### STAFF RECOMMENDATION

1417 Russell Street

February 17, 2021

**Application:** New Construction—Infill and Outbuilding  
**District:** Lockeland Springs-East End Neighborhood Conservation Zoning Overlay  
**Council District:** 06  
**Base Zoning:** R6  
**Map and Parcel Number:** 08313028200  
**Applicant:** Agynes Chrzan, Legacy South  
**Project Lead:** Melissa Baldock melissa.baldock@nashville.gov

**Garage Elevations**

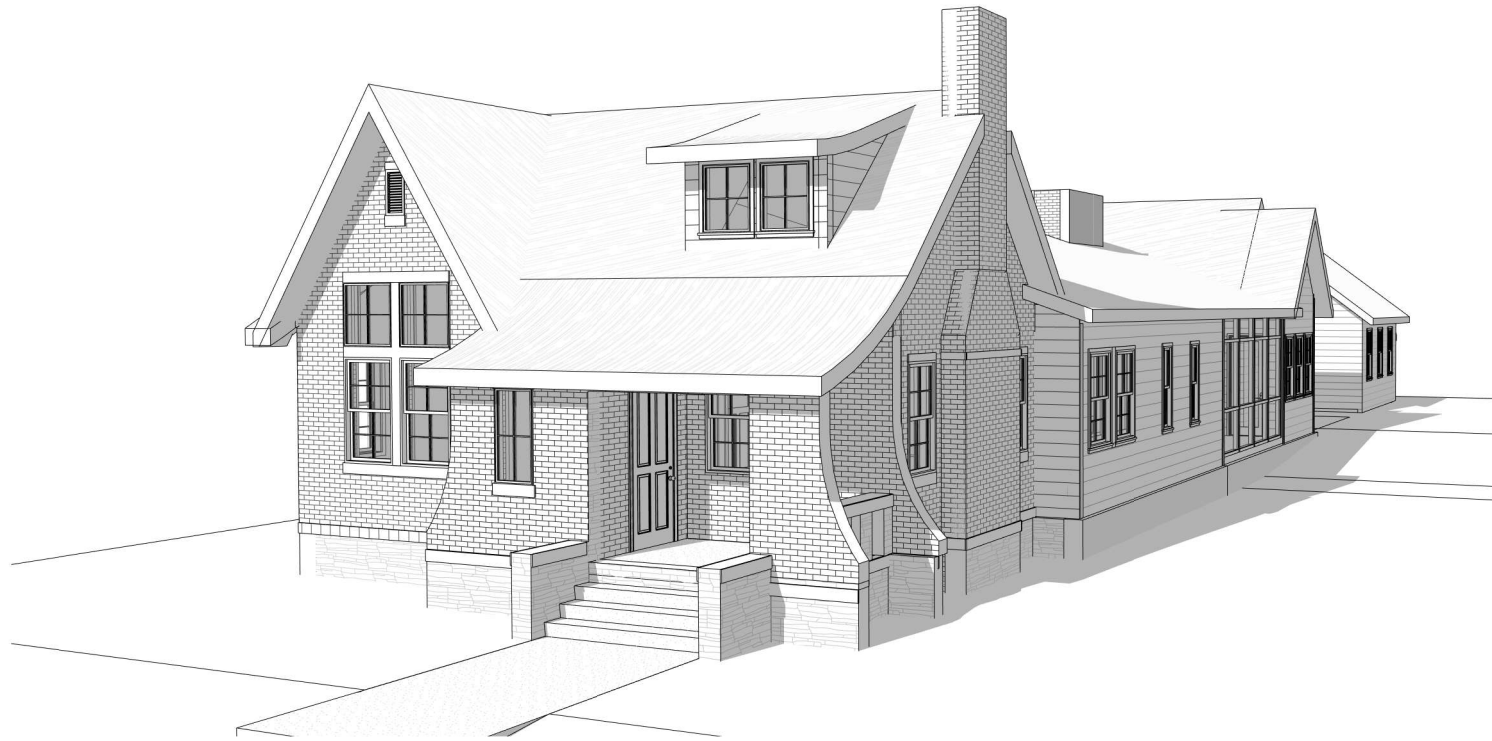
Outbuildings: The applicant is proposing a one-and-a-half story outbuilding.

<b>Proposed Element</b>	<b>Proposed Form</b>	<b>Typical of district?</b>
Primary form	Gable	Yes
Primary roof slope	9/12	Yes
Dormer form	Shed	Yes
Dormer slope	3/12	Yes

The proposed outbuilding has a simple design that is subordinate to the primary structure and appropriate for outbuildings. The design meets Section II.B.8.a of the design guidelines.

Roofing	Asphalt shingle	Needs final review	Yes	Yes
Trim	Fiber-cement	Smooth	Yes	No
Windows	Not indicated	Needs final approval	Unknown	Yes
Doors	Not indicated	Needs final approval	Unknown	Yes
Garage door	Insulated metal	Needs final approval	Yes	Yes

With the staff's final approval of the roof color and windows and doors, staff finds that the known materials meet Section II.B.8.a.
